SERVICE BULLETIN

APPLICABILITY: 2014MY Forester Turbo Models

NUMBER: 02-139-13

SUBJECT: Change to Oil Level Switch

COUNTERMEASURE IN PRODUCTION

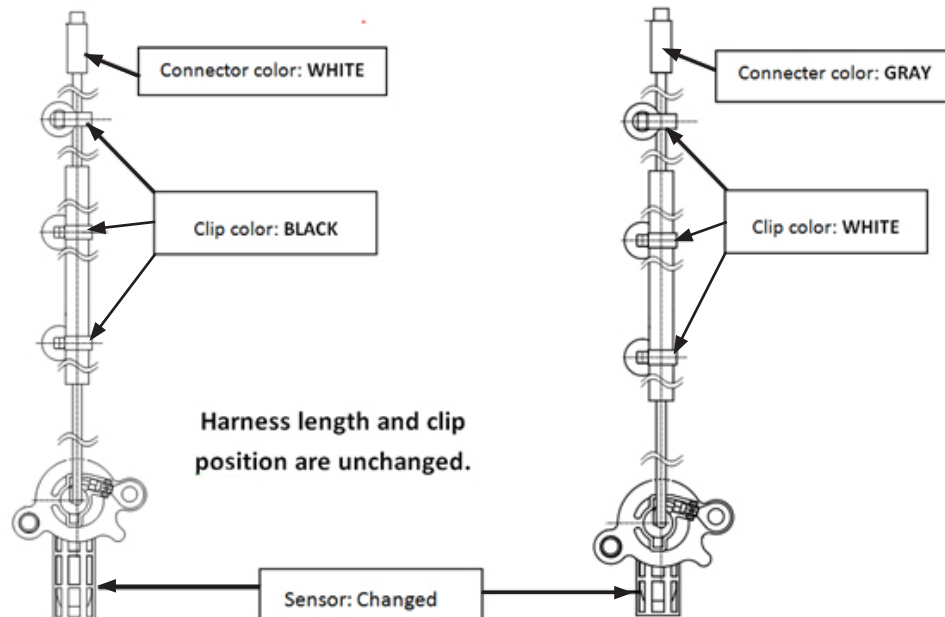
This Bulletin provides information regarding changes made to the oil level switch assembly designed to improve its accuracy. In addition, the wiring harness connector and harness retaining clip colors have been changed for identification purposes to help distinguish between the original and the new part.

The new oil level switch assembly was incorporated into production on February 14, 2013 starting with VIN E*417779 and Engine Number 929283.

New Part: 11136AA120

Original Part: 11136AA100

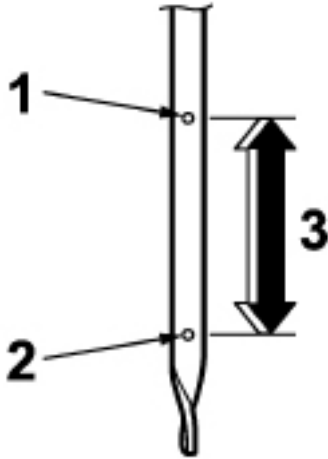
NOTE: If the engine oil on the dipstick is found to be below the operating range (#3 shown below), determine if the low oil level is due to normal oil consumption or another cause which will need to be determined before proceeding further.

1. When receiving a customer concern of the engine oil level warning lamp coming on, confirm the engine oil level is within the operating range (#3) on the dipstick as shown below. Park the vehicle on a level surface and stop the engine. If you check the oil level just after stopping the engine, wait a few minutes for the oil to drain back into the oil pan before checking the level.

- 1) Full Level
- 2) Low Level
- 3) Approximately 1.1 US qt (1.0 liter, 0.9 imp qt) from low level to full level
